LIGO-D080252 Rev.B OMC Tip/Tilt Shutter

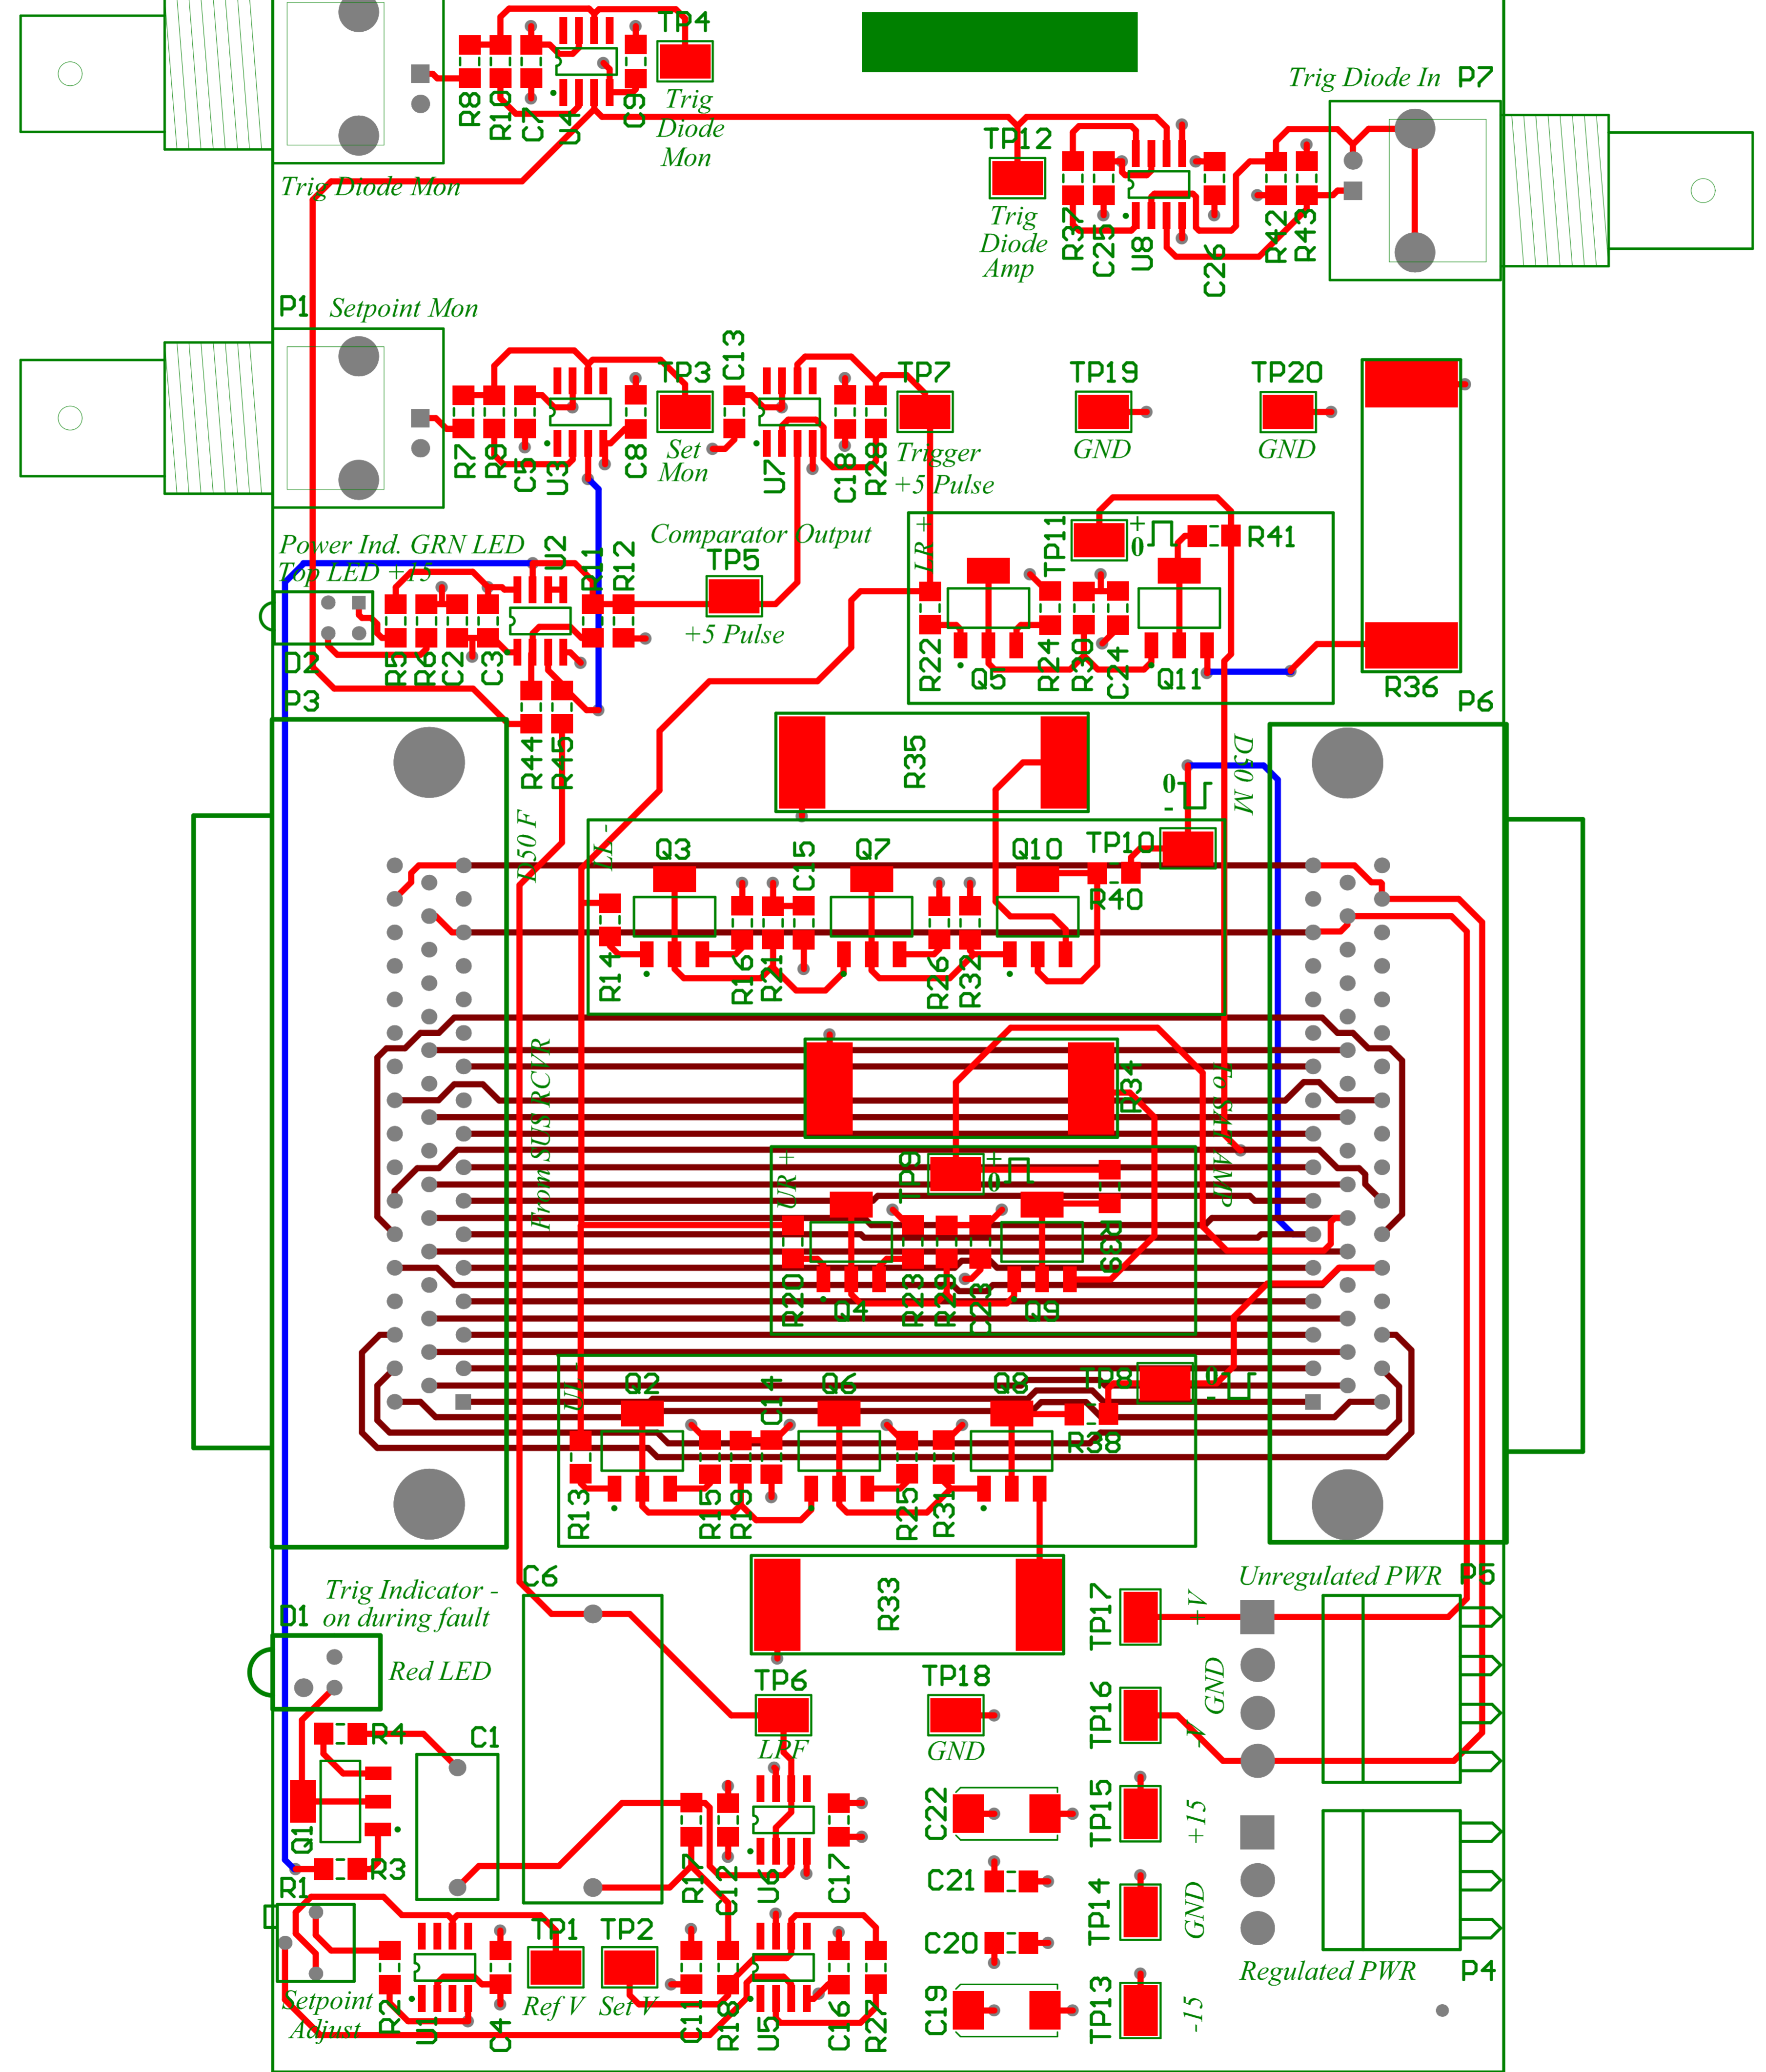
Revision Notes:  
 Rev A - Initial Release of board  
 Rev B - Corrected the footprint of the NPN and PNP transistors  
 Changed from driving "Coil Out" to "Coil Rtn" due to error in suspension wiring diagram  
 Changed hysteresis on LM311 due to instability  
 Flipped trigger indicator diode polarity due to error  
 Changed biasing component values on transistor stages to optimize response  
 Rev B1 - Resistor R2 value changed from 1k to 0 ohms as the default in order to allow values of trigger voltage down to zero  
 Updated the current draw numbers to reflect the higher current when triggered  
 Rev B2 - Series resistors R33, R34, R35 and R36 changed from 274 ohms to 100 ohms to provide higher current to the Tip/tilt coils  
 Updated the pulsed voltage labels at each coil interface to reflect the higher current pulses  
 Rev B3 - Changed from driving "Coil Rtn" to "Coil Out" (basically going back to the way things were originally)

Changed TP11 drive point to "LL Coil Out" from "LR Coil Rtn"  
 Changed TP10 drive point to "LR Coil Out" from "LL Coil Rtn"  
 Changed TP9 drive point to "UL Coil Out" from "UR Coil Rtn"  
 Changed TP8 drive point to "UR Coil Out" from "UL Coil Rtn"  
 [This change was made to put the current insertion point during shutter action to the supply leg of the coils instead of the return leg.  
 I verified this is now correct at LLO, V. Sandberg has verified the polarities and connections are the same at LHO.  
 Updated the current pulse cartoons to reflect the correct polarity at each drive point
